SERVICE BULLETIN

Original Issue Date: **5/94**Model: **6.5RMY, 10RY/RZ, and 12RY/RZ**Market: **Industrial**Subject: **LP Vapor Gas Operation**

SB-527

**Figure 1. LP Vapor Gas Fuel Regulator**

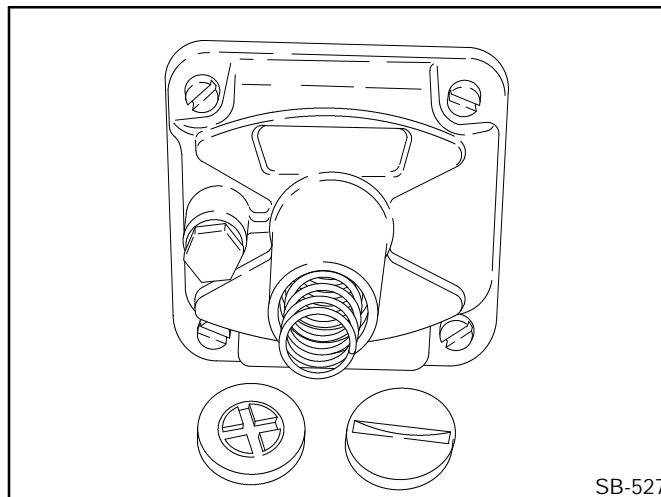
Disregard fuel regulator conversion information for the following model/spec numbers:

Because of the design and vertical mounting position of the gas fuel regulator do not remove the retainer and spring when converting from natural gas to LP gas fuel. Starting and operating problems can occur if components are removed. Effective 8-15-95 all current production

models will use hang tag part no. 226682 to identify units which do not require conversion using the spring and retainer.

Remove the spring and retainer from the fuel regulator for all LP vapor gas models not listed in this service bulletin. See Figure 1.

Remove and discard fuel conversion hang tag part no. 258558 if mounted on any generator set cited above.
